**Addendum-2 to MMDTS 19027, Rev.-01 & Rev.-02**

Addendum-1 to MMDTS 19027,Rev.-01 & Rev.-02

<b>SPECIFICATION</b>	<b>SCHEDULE OF TECHNICAL REQUIREMENTS FOR ELECTRO-PNEUMATIC PRESSURISED FLUSHING SYSTEM FOR LHB COACHES</b>	<b>MMDTS 19027, REV.- 1 Page 1 of 14 Date: 07.08.2020</b>
----------------------	---	---

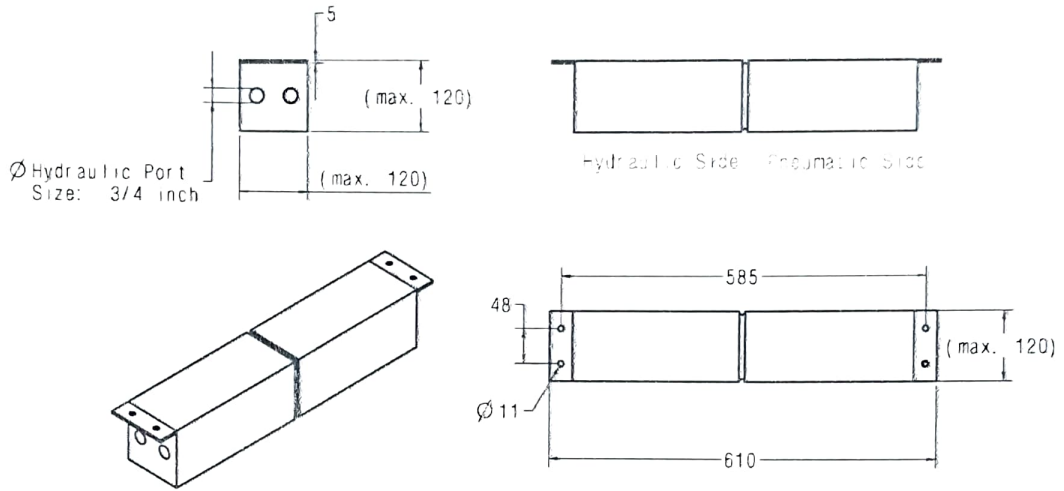
Table-1 SN.10	Note added to item no. 10 (Electro-Pneumatic Control Panel and Push Button switch panel)	In addition to the requirements already mentioned in MMDTS 19027 Rev-01/02, the following requirements shall also be applicable:- <ol style="list-style-type: none"> <li>1. MCB of suitable ratings is to be provided in the control panel.</li> <li>2. There shall be two separate control panels; one each for pneumatic and</li> </ol>

Clause no.	Brief details in the Existing Rev-01/02	Clause included/modified
		<p>electric components. Pneumatic control panel shall house Solenoid valve (as has air exhaust port), AFR, pneumatic tubings and any other pneumatic components. Electrical control panel should house MCB, Timer, SMPS, electrical wirings or any other electric/electronic components.</p> <p>3. The control panels enclosure shall be powder coated with colour shade RAL DS 9000.)</p> <p>4. The overall size of both the control panel shall be as per Annexure-B.</p>
Table-1 SN.13	<u>New Clause</u>	<p><b>Provision of Y-strainer:-</b> A Y-strainer (3/4" BSP) of SS AISI 304 shall be installed in the SS water inlet line for the water pressurization system to filter, or strain, out particulates from water.</p> <p>1. The strainer shall be placed for easy frequent cleaning. The Y branch shall be oriented downwards to avoid accumulated dirt to fall inside the system.</p>

Enclosure for water pressurizing systemAnnexure-BControl Panel Enclosure

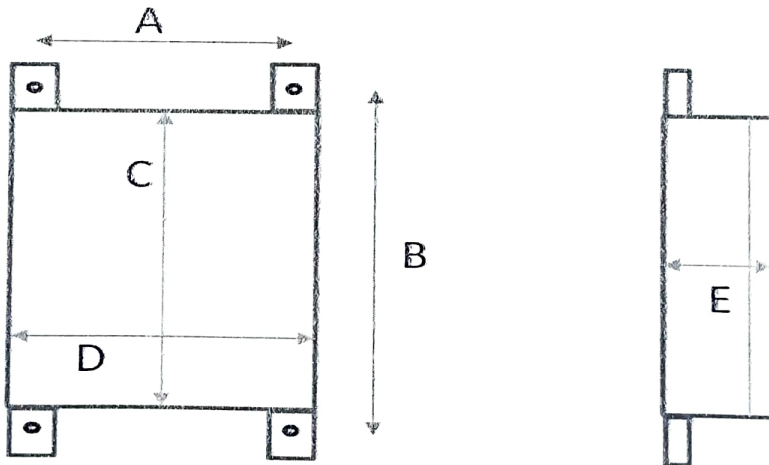
Material for control Panel shall be Stainless Steel- AISI 304 (thickness-1 mm sheet). Control panels shall be powder coated with colour shade RAL DS 9000

Dimensions in (mm)	A	B	C	D	E
Size for Control Panel no. 1 for (AFRL & Solenoid)	255	260	220	275	90
Size for Control Panel no.2 for (MCB, Timer SMPS and other electrical equipments)	255	240	200	275	90
